The starter drives ZEN 0837 and 0919 are similar in dimensions, but there is a difference in the position of the lever. See below:

0837

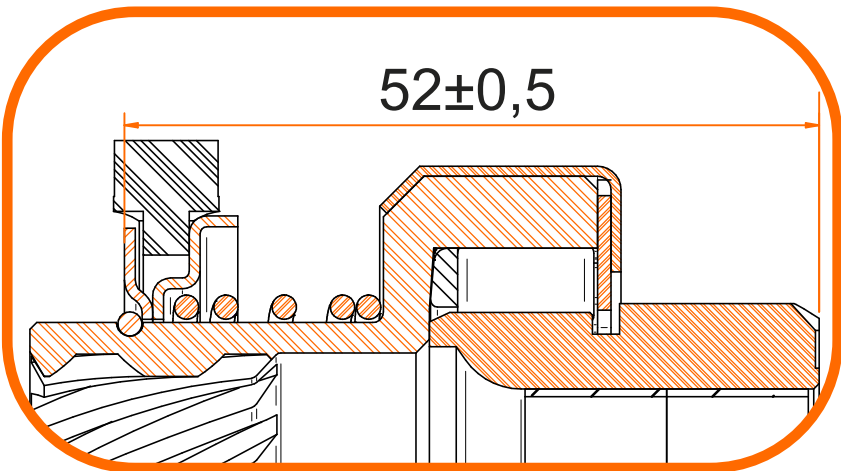
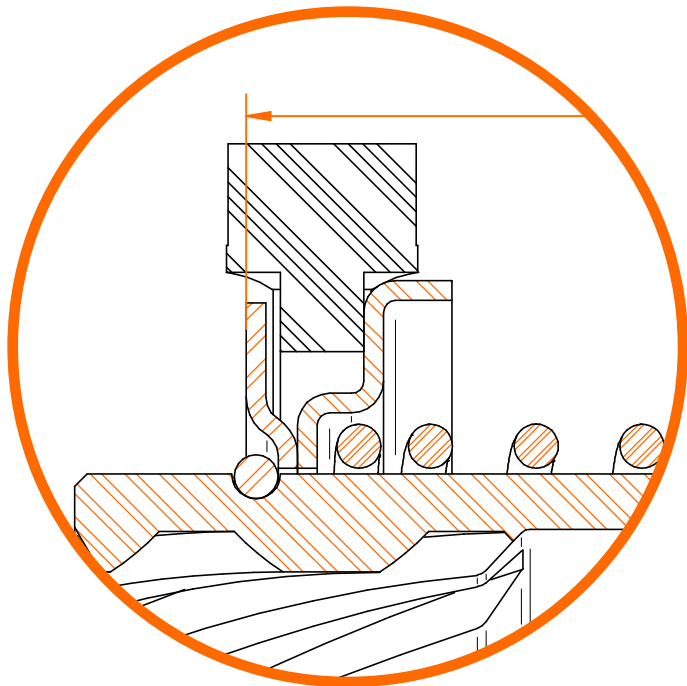
• These drives are not interchangeable, because the lever will not couple correctly to the fiber ring.
